**25/03979/FUL | Installation of 2x artificial sports pitches, associated warm up area, floodlighting, fencing, areas of hardstanding and infrastructure. | 79 Myreside Road Edinburgh EH10 5DB**

## Objection from Spokes Planning Group, September 2025

Fig 1: City Plan 2030 Extract

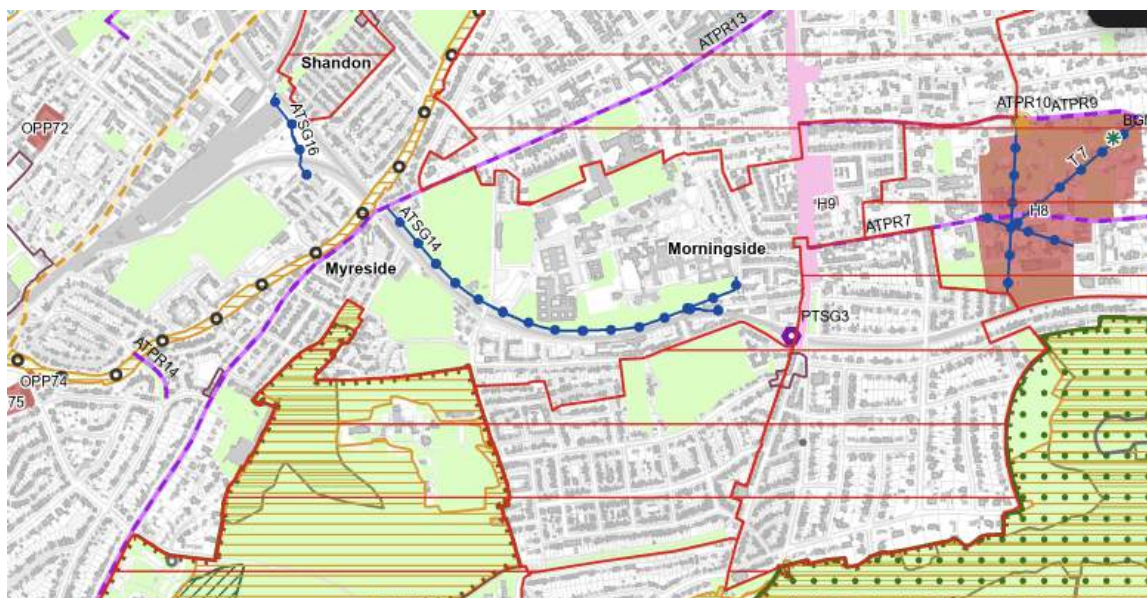
We believe there should be mention of the path parallel to the southern edge of the site in the application, as this would make a difference to active travel locally. This route is an existing safeguard numbered 'ATSG14' in the [City of Edinburgh City Plan 2030](#) documentation.

This would link the Union Canal (NCN 75/754 & John Muir Way) at Meggetland (also Slateford Railway Station) to Morningside via the already built east-west route through the Royal Edinburgh Hospital and onward to Morningside via Millar Crescent. The aim of this safe guard is to create a safe active travel link to/from the school and to/from the Union Canal to the west & Morningside to the east as can be seen in Extract of City Plan 2030 South East Proposals Map.

Fig 5 & 6: Extracts of drawings showing site boundary incorporating path

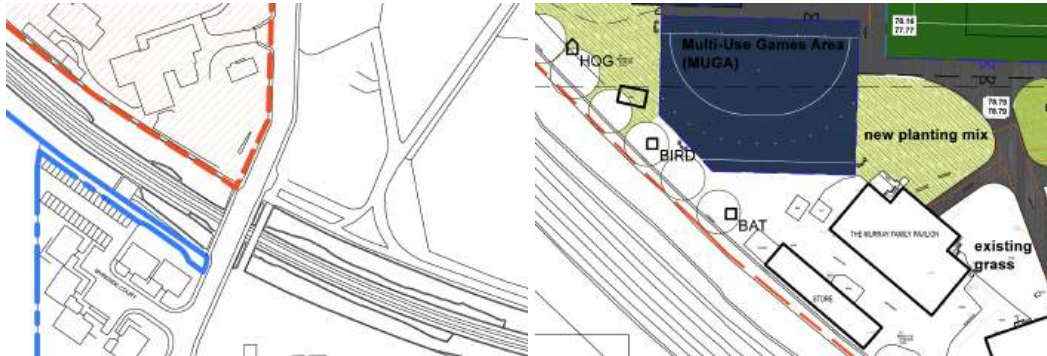
The application Location Plan and other drawings in the planning submission appear to show the existing path within the scope of the site boundary and therefore part of the application. See extract below;

The location plans also don't show the correct context without the new Royal Edinburgh Hospital Building, including the shared use path to the east and the T junction road access into the REH. Therefore it is no wonder that the applicant hasn't considered active travel and the safeguard as part of the application if the drawings don't even show them. This is misleading and should be corrected.

There are no sections showing the boundary wall at the adjacent path in the application. These should be provided to show how the boundary wall is affected and how the path can be routed through the GWC site now or in the future.
